UNITED STATES DEPARTMENT OF COMMERCE United States Patent and Trademark Office Address: COMMISSIONER FOR PATENTS P.O. Box 1450 Alexandria, Virginia 22313-1450 www.uspto.gov

APPLICATION NO.	FILING DATE	FIRST NAMED INVENTOR	ATTORNEY DOCKET NO.	CONFIRMATION NO.	
10/544,285	08/03/2005	Wolfgang Kentner	2003P00255WOUS	1328	
7590 06/17/2009 John T Winburn			EXAMINER		
BSH Home App 100 Bosch Blyd	oliances Corporation	NORMAN, MARC E			
New Bern, NC 28562			ART UNIT	PAPER NUMBER	
				3744	
			MAIL DATE	DELIVERY MODE	
			06/17/2009	PAPER

Application No.	Applicant(s)				
Office Action Comments	10/544,285	KENTNER ET AL.				
Office Action Summary	Examiner	Art Unit				
	Marc E. Norman	3744				
The MAILING DATE of this communication appears on the cover sheet with the correspondence address Period for Reply						
A SHORTENED STATUTORY PERIOD FOR REPLY IS SET TO EXPIRE 3 MONTH(S) OR THIRTY (30) DAYS, WHICHEVER IS LONGER, FROM THE MAILING DATE OF THIS COMMUNICATION. - Extensions of time may be available under the provisions of 37 CFR 1.136(a). In no event, however, may a reply be timely filed after SIX (6) MONTHS from the mailing date of this communication. - If NO period for reply is specified ab

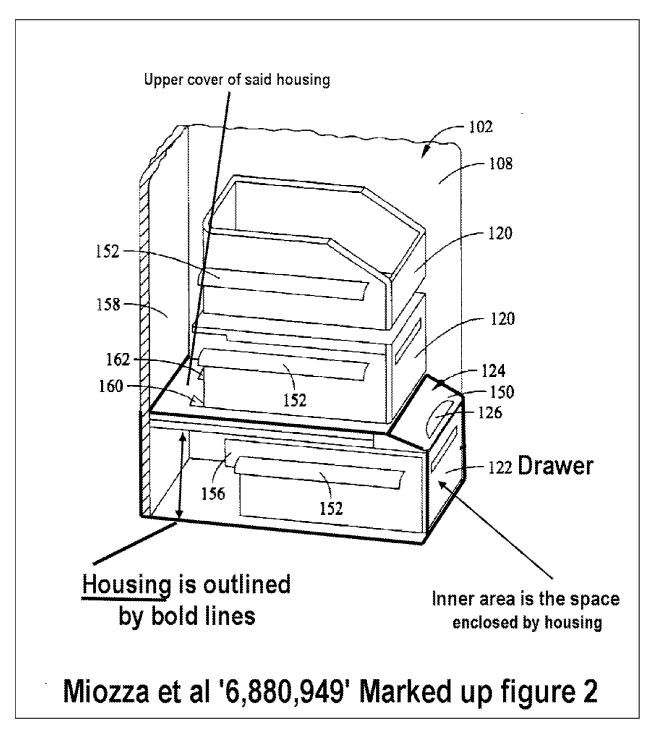
In re claim 14, Miozza et al disclose a refrigeration appliance, comprising: a housing (see marked up figure 2); said housing enclosing an inner area (122, figure 2); said inner area enclosed by a door (136, figure 1); a carrier module (figure 7) located in said housing (see marked up figure 2); and said carrier module including a control circuit (174, figure 3) for controlling (via 172, figure 3) the refrigerating capacity of the refrigeration appliance (figure 1) in said inner area (122, air space within pan, figure 2) depending on a temperature measuring signal (see temperature sensors recited in C4, L21) related to the temperature in said inner area (122, air space within) (see C8, L28-38 re controlling drawer temperature), at least one operating element (264 temp selector, C8, L47) for at least one of adjusting an operational parameter (temperature of drawer) and a display element (176, figure 3) for displaying an operational parameter (temperature settings, C6, L18-20) of said refrigeration appliance (figure 1) and at least one illuminating agent (206, figure 7) for illuminating at least some of said inner area (see

In re claim 15, Miozza et al disclose the invention above and further disclose a compartment (124, C7, L10) for said carrier module (figures 6-8, C9, L40-47) formed in an upper cover (see marked up figure 2) of said housing (see marked up figure 2).

In re claim 16, Miozza et al disclose invention above and further disclose said cover (210) designed as a side plate (see figure 2, upper cover portion) forming the upper portion of the housing exterior (see marked up figure 2).

In re claim 27, Miozza et al disclose the invention above and further disclose a refrigeration appliance, comprising: a housing (see marked up figure 2); said housing enclosing an inner area (122, space within); said inner area enclosed by a door (136); a compartment formed in an upper cover of said housing, and a carrier module (figure 6) located in said housing compartment (see marked up figures 2); and said carrier module including a control circuit (174, figure 3) for controlling (via 172, figure 3) the refrigerating capacity of the refrigeration appliance (figure 1) in said inner area depending on a temperature measuring signal (see temperature sensors recited
